UNITED STATES PATENT AND TRADEMARK OFFICE

APPLICATION NO.	FILING DATE	FIRST NAMED INVENTOR	ATTORNEY DOCKET NO.	CONFIRMATION NO.
10/585,514	09/26/2006	Memduh Guney	4398-567	3671
23117	7590	05/26/2009	EXAMINER	
NIXON & VANDERHYE, PC 901 NORTH GLEBE ROAD, 11TH FLOOR ARLINGTON, VA 22203				STUART, COLIN W
3771		ART UNIT		PAPER NUMBER
05/26/2009		MAIL DATE		DELIVERY MODE
				PAPER

DETAILED ACTION

FIG. 6

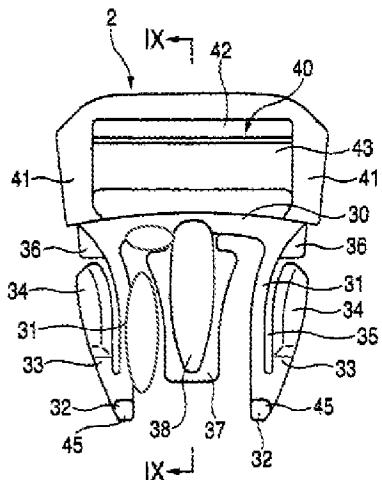
In regards to claim 32, Matoba shows a locking clip capable of being used for removably coupling to a frame and headgear assembly for a respiratory mask which includes a main body 41 with a front portion 30 and a rear portion 2 in which the front portion is to be removably coupled with a frame of a respiratory mask and the rear portion coupled to a headgear assembly (see Fig. 6). Matoba also shows the rear

portion with a crossbar 40 that forms an opening 42 for a strap to be passed and a front portion which includes at least one resiliently flexible spring arm 45 (see Fig. 6). The spring arms each include a first end 32 which include a locking tab 34 at a free end and a second end 36 attached to the main body. The spring arm also includes a proximal portion 31 extending from the second end and a central portion 33 extending from and angled with respect to the proximal portion (see Fig. 6). The proximal portion of Matoba's locking clip's proximal portion is spaced from the main body by a first gap and the central portion is spaced from the rear portion by a second gap, in which the two gaps form a general L-shape (see marked copy of Fig. 6 above).

In regards to claim 35, Matoba's locking clip includes a pair of spring arms 45 (see Fig. 6).

In regards to claim 36, Matoba shows a locking clip which also includes a central support tab 38 positioned between the pair of spring arms (see Fig. 6) and adapted to be inserted into a slot of a frame to guide the locking clip into engagement with the frame (see Fig. 1).

In regards to claim 37, the central support tab 38 of Matoba's locking clip extends forward from each spring arm (see Fig. 6).
